TECHNICAL INSTRUCTION NO. 29

T.51 DART 17R

Mandatory Modification No.66

STRENGTHENING OF MANUAL RETRACTABLE UNDERCARRIAGE

UNDERCARRIAGE REPAIR SCHEME

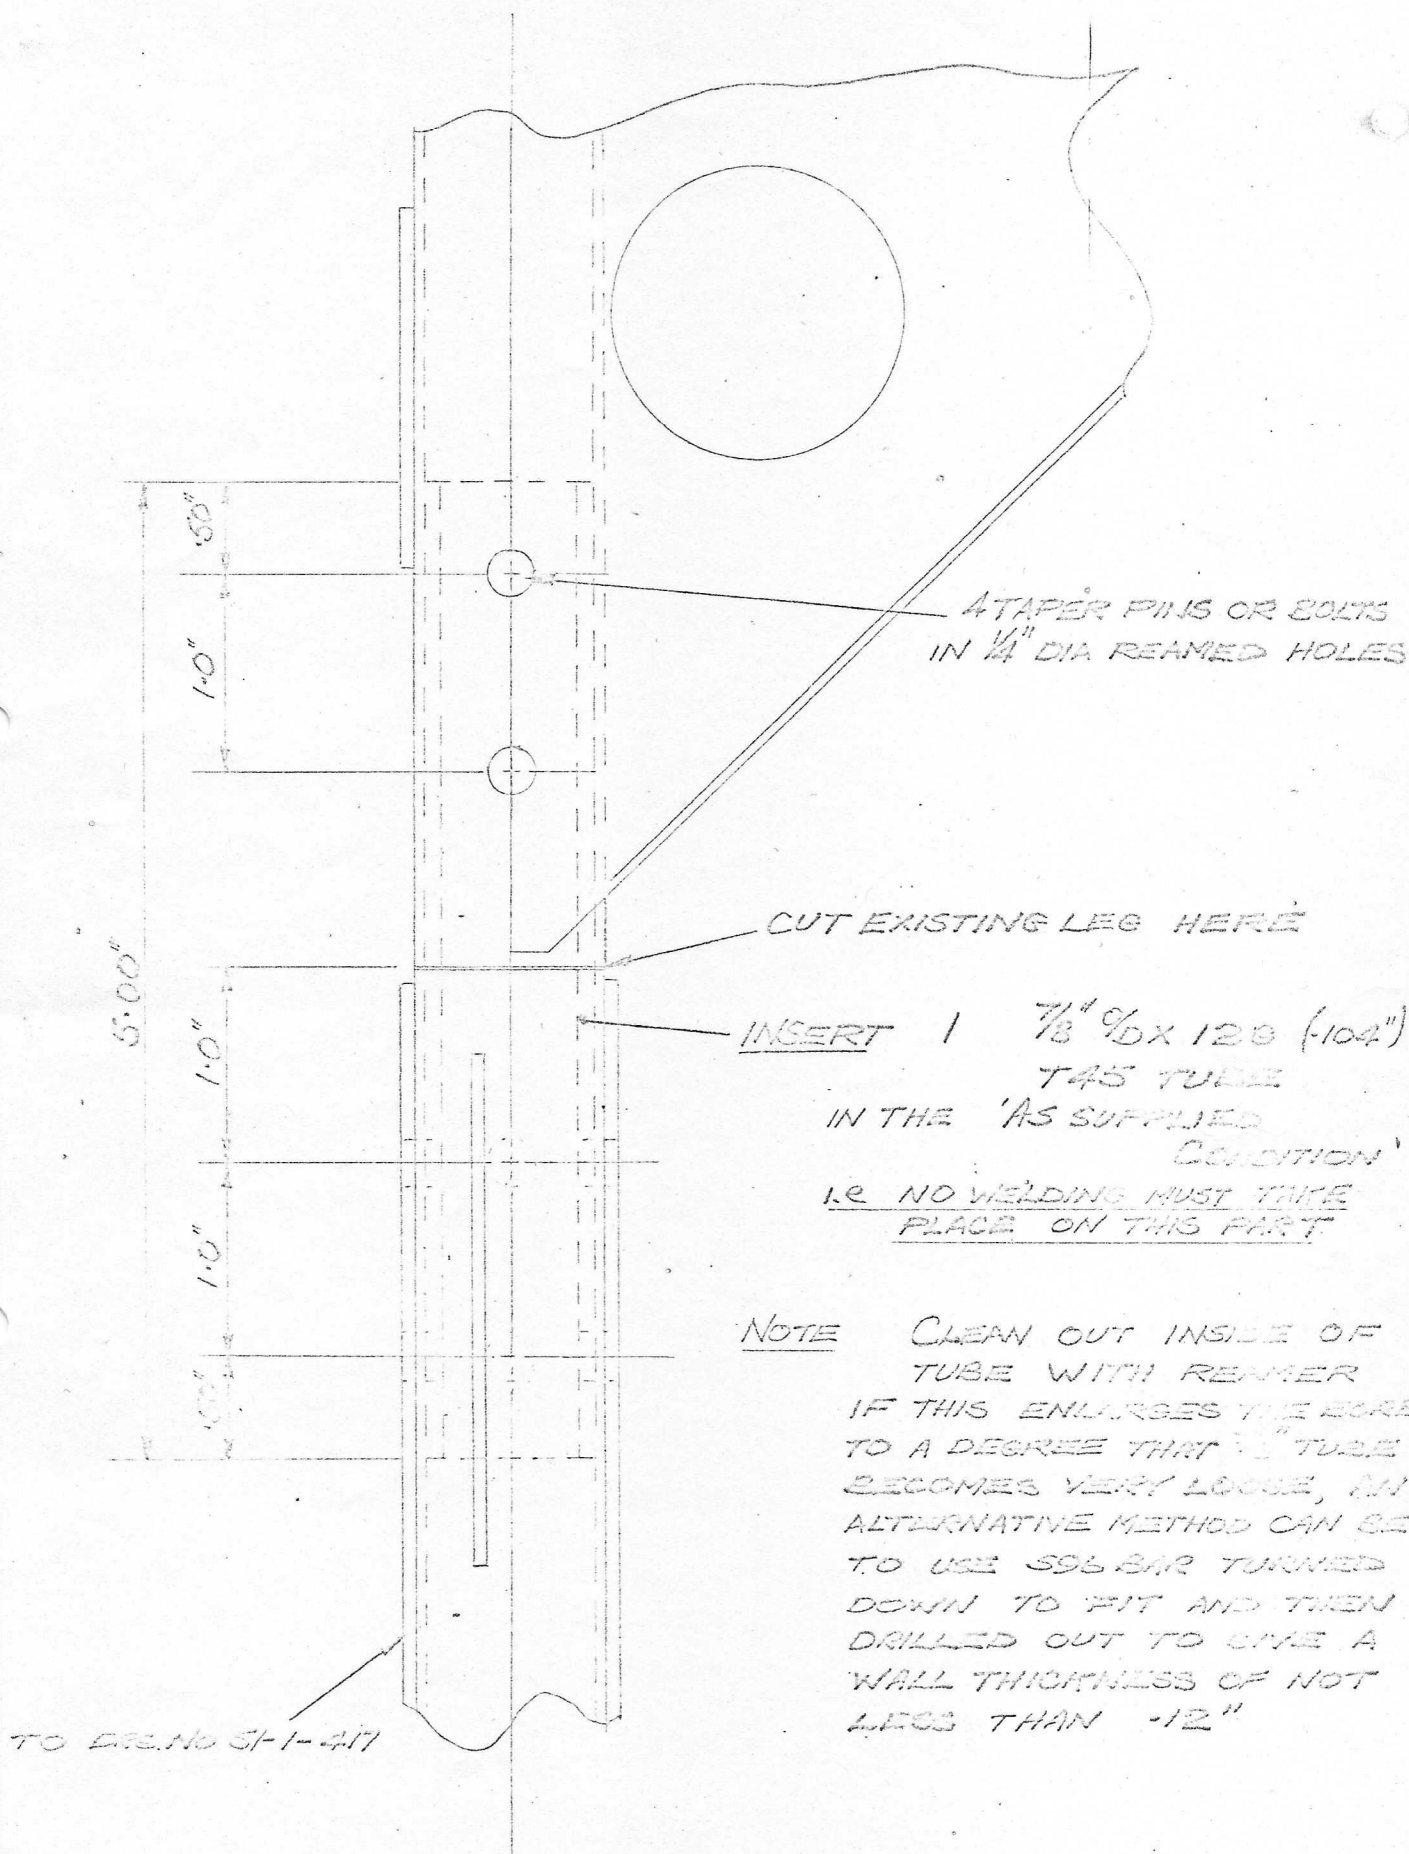
Due to a small number of main undercarriage fork failures a design change has been made, introducing strengthening of the Fork.

This modification is in the form of an internal tube inserted into the existing 1.0"  $\phi$ /D Tubes.

CUT EXISTING LEG HERE

INSERT 1  $\frac{7}{8}$ "  $\phi$  X 120 (-104")  
T45 TUBE  
IN THE 'AS SUPPLIED  
CONDITION'  
I.E. NO WELDING MUST TAKE  
PLACE ON THIS PART

NOTE CLEAN OUT INSIDE OF  
TUBE WITH REAMER  
IF THIS ENLARGES THE BORE  
TO A DEGREE THAT THE TUBE  
BECOMES VERY LOOSE, AN  
ALTERNATIVE METHOD CAN BE  
TO USE S96 BAR TURNED  
DOWN TO FIT AND THEN  
DRILLED OUT TO GIVE A  
WALL THICKNESS OF NOT  
LESS THAN .12"
